## PLANNING REPORT

### PLANNING AND ZONING COMMISSION

**4. Shoppes at River Ridge – Montgomery Inn 4565 West Dublin-Granville Road  
09-113CDDS Corridor Development District Sign**

Proposal: Add a sign to the main (east) building elevation facing the parking lot. The site is located on the south side of West Dublin-Granville Road, approximately 750 feet east of the intersection of Riverside Drive.

# EXISTING SIGN

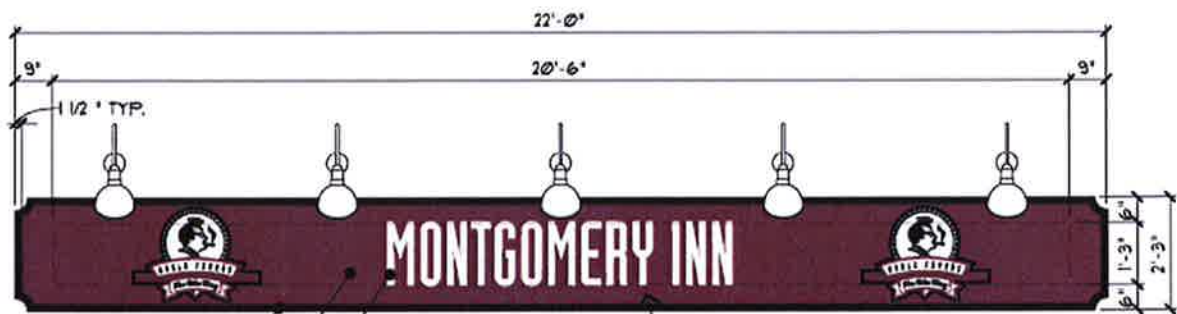
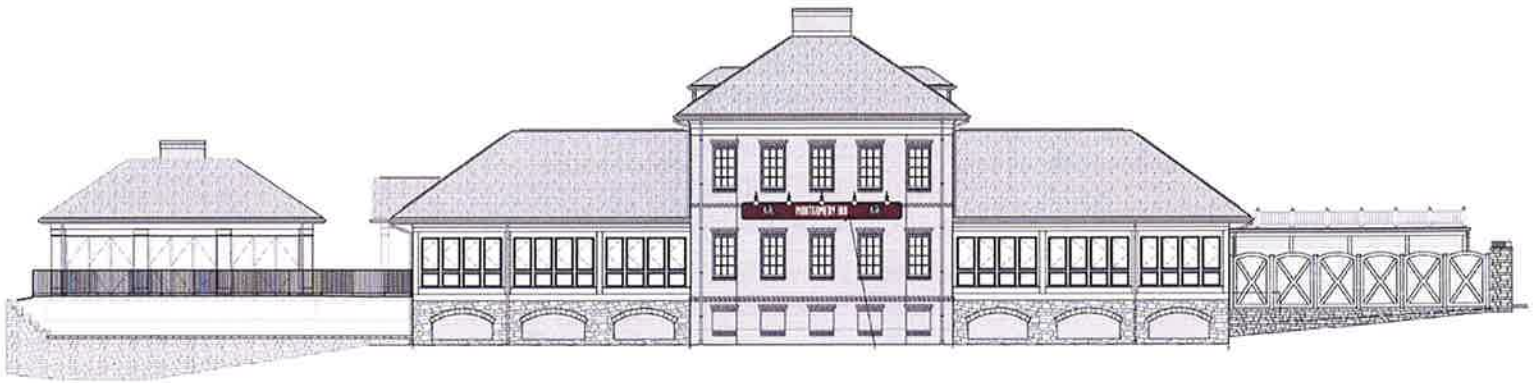
The Montgomery Inn restaurant has one existing, 50-square-foot plaque sign located on the west side of the building facing Riverside Drive. The existing sign has three colors (*Sherwin Williams Pure White* lettering, *Sherwin Williams Rookwood Red* background, and *Sherwin Williams Tricorn Black* border) and has two logos on each side of the “Montgomery Inn” sign copy. Five gooseneck light fixtures are evenly spaced above the sign. No changes are proposed for this sign.

# PROPOSED SIGN

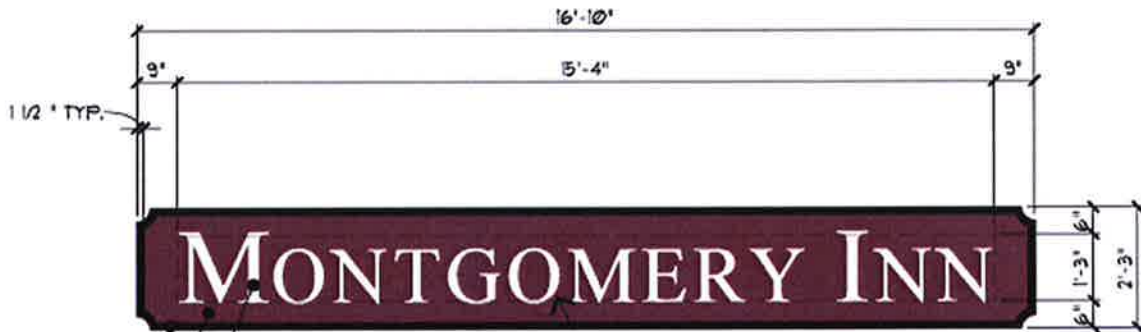
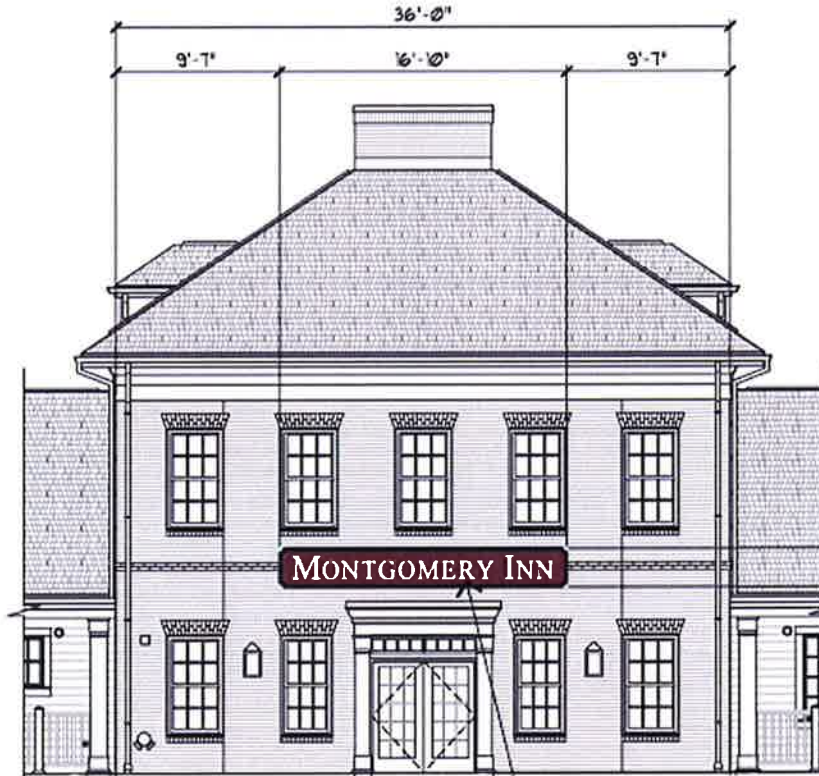
- Dimensions: The proposed sign is 2 feet, 3 inches in height and 16 feet, 10 inches in width to be installed 13 feet from grade centered over the main restaurant entrance, which meets Code and the approved sign plan.

- Area: The proposed sign is 38 square feet on a 36-foot-wide tenant frontage. When combined with the existing 50-square-foot sign, the total sign area would exceed the maximum area of 80 square feet permitted by Code.

- Colors & Design: The proposed sign colors include white lettering (*Sherwin Williams Pure White*) with a red background (*Sherwin Williams Rookwood Red*) and a black border (*Sherwin Williams Tricorn Black*), which will coordinate with the colors used on the existing sign and the approved sign plan. The proposed font is different from the existing sign, and no logos are proposed; however, the font design will coordinate with the design of the existing restaurant.

- Lighting: No sign lighting is proposed.

The Commission also commented that a second sign could be acceptable provided sign height and area met Code and that the two signs were proportional. Since each tenant is permitted a maximum of 80 square feet of sign area based on the size of the tenant frontage, Planning recommends that the total area for the two signs be limited to a maximum of 80 square feet (Condition).

**Condition:** That the total area for the two signs be limited to a maximum of 80 square feet.
